APPENDIX I

Proposed Comprehensive Residential and Commercial Development atop Siu Ho Wan Depot

Development Scheme

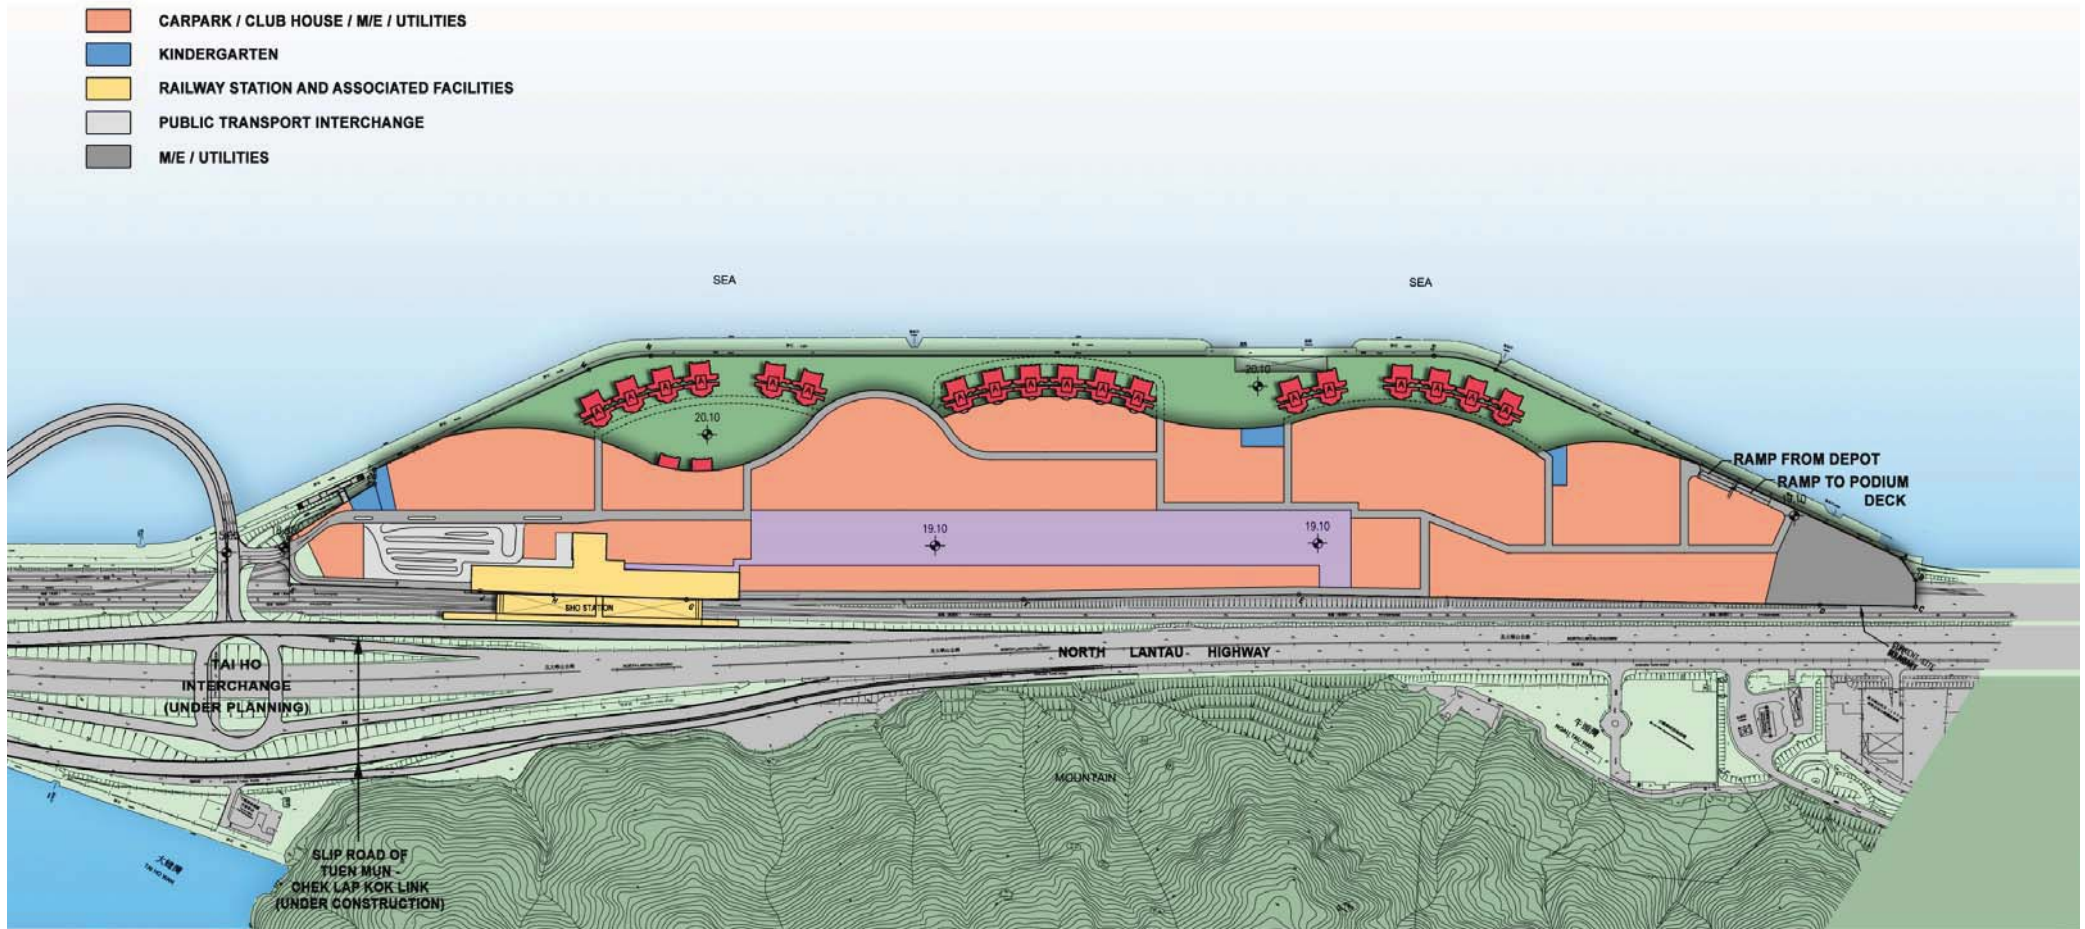
<u>Request</u>	<u>Response</u>
<p>(a) <i>Information on further elaboration and clarification of the landscape and visual mitigation measures including the building layout / design, the massing / heights of the buildings and treatment to the façade / podium;</i></p>	<p>The proposed conceptual development scheme (Annex A, 9 pages) has incorporated a list of planning and design considerations including building disposition, height profile (stepped podium), permeability (breezeways and airpaths), greening and façade treatment to minimise negative impacts to the surrounding landscape. In formulating the proposed conceptual development scheme for the EIA, due considerations have also been given to address relevant Study Brief requirements and other guidelines e.g. EIAO Technical Memorandum, Sustainable Building Design Guidelines and Urban Design Guidelines, etc. These included baseline study under the context of the landscape and visual impact assessment, which had considered Physical Aspects (e.g. geology, topography, soils, vegetation, hydrological and climate features including microclimate (such as landscaped garden)), Human Aspects (e.g. coastal waters, artificial shoreline, plantation, urbanized development and roads & urban infrastructure) and Aesthetic Aspects (e.g. the landscape setting within the visual envelope including the views available, visual amenity and visual character) of the Project. The potential outcomes are illustrated in the artist impressions on the conceptual greening framework at the civic square and the landscaped terrace (Annex B, 2 pages). About 30% of greenery would be provided within the Project and would transform SHD into a sustainable green urban node. Please refer to S11.4-11.6 and S11.8 of the EIA Report for information.</p> <p>The scheme design will be further enhanced at the detailed design stage to allow further permeability and variations in building height. As the development will be implemented under many development packages and over a long period of time, the buildings will naturally form a township of different designs, colours, textures and materials which will reduce the visual massing and eliminate monotonous appearance. Further articulation of the podium deck at detailed design and the adoption of soft landscaping including green walls will allow the development to harmonise with the landscape character of the surrounding area.</p>

Indicative Floor Layout (Option 1)

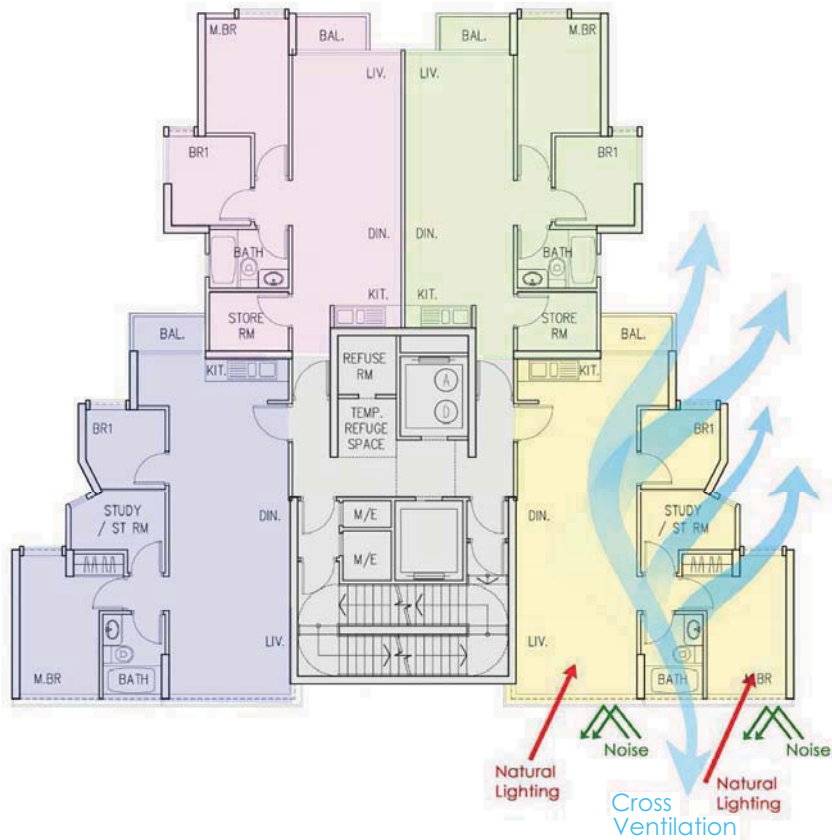
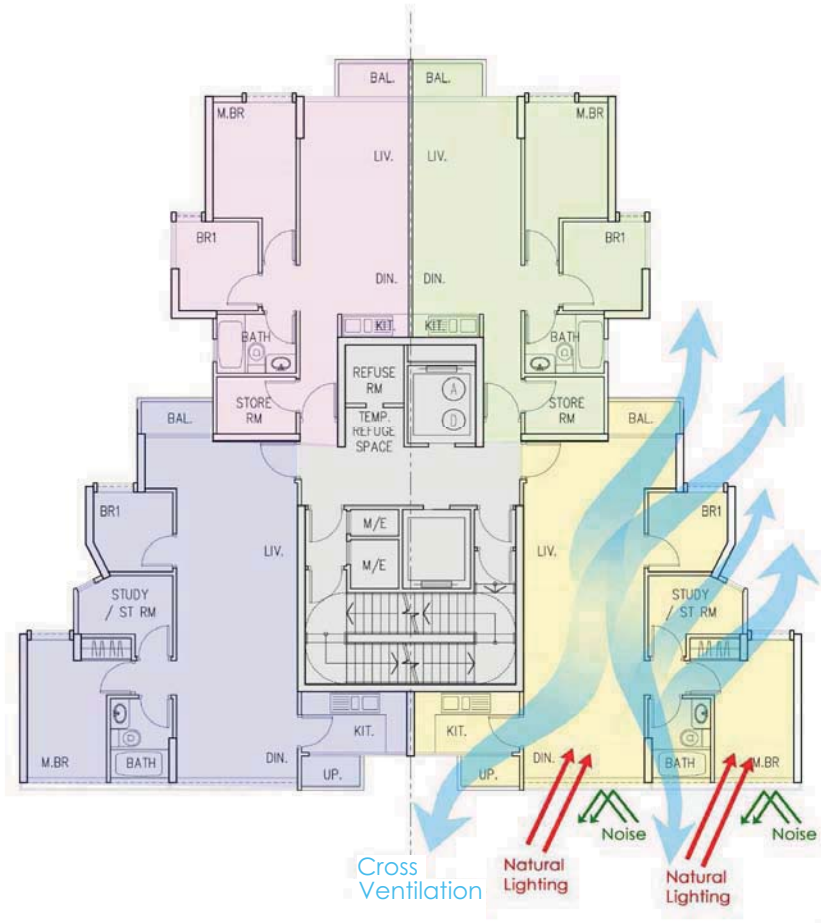
<p><i>(b) Information on further elaboration and clarification of the alternative designs to minimise the provision of fixed windows for sensitive façade at the southernmost row of residential buildings;</i></p>	<p>The current design has located all the openable windows of living rooms and bedrooms facing to the north for the buildings of self-protecting building design along the southern site boundary fronting North Lantau Highway (i.e. the southernmost row of buildings) to minimise the impacts of road traffic noise and rail noise. Openable windows will be provided at non-noise sensitive rooms to facilitate cross ventilation. Fixed glazing will be provided at the habitable rooms at the southern façade to provide extra daylight and views in addition to the openable windows at the north (Annex C, 1 page).</p> <p>Further investigation will also be made at detailed design stage to maximise cross-ventilation. With the advancement in noise mitigation technology in the future, further use of acoustic window/balcony as noise mitigation measures will be reviewed in the implementation stage.</p> <p>Please refer to S2.4.2.15, S2.4.3.11 and S2.4.3.12 of the EIA for information.</p>

Figure 1 – Rock Level at SHO Central Location

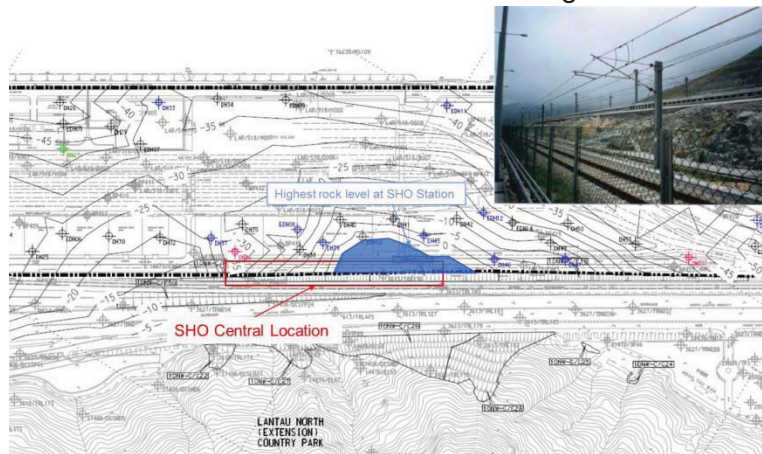
<p><i>(c) Information on further elaboration and clarification of the considerations given to choose the Western Station option instead of the Central Station option.</i></p>	<p>The key station design considerations and site constraints have been taken into account which included minimizing the disturbance to depot operations, train services and possible risks at the construction of new station, limiting the potential impacts to North Lantau Highway (NLH), Lantau North (Extension) Country Park and Tai Ho Priority Site, construction waste caused by station site formation works, and the transport planning considerations of the future public transport interchange (PTI) and Tai Ho Interchange. Please refer to Annex D (2 pages) for details.</p> <p>With respect to the western station location, provisions have been made within the topside development for a range of options for residents and visitors to reach the railway station: a retail spine is proposed in the middle of the topside development with direct connection to the station to extend the reach of the station to the East, making the journey to the station enjoyable and provide daily convenience to the residents. Extensive covered walkway system at the podium level connecting the residential towers to the station will be provided. In order to encourage the use of bicycle in support of a sustainable environment, bicycle tracks at the podium level and bicycle park near the station will also be provided.</p>

- The platform of the station under this option will be located at the tracks which are being share-used by TCL/AEL and longer additional TCL tracks modification would be required.
- Considering station platform has to be on flat level, extensive site formation works would need to be conducted in the vicinity of the operating tracks at the central location for Central Station option. The hard rock located at the location of Central Station will induce extra difficulties and great risks to the modification works next to the live tracks with both AEL/TCL running at over 130kph at this location. The extensive site formation works which would result in higher construction waste is also considered to be less environmental friendly.
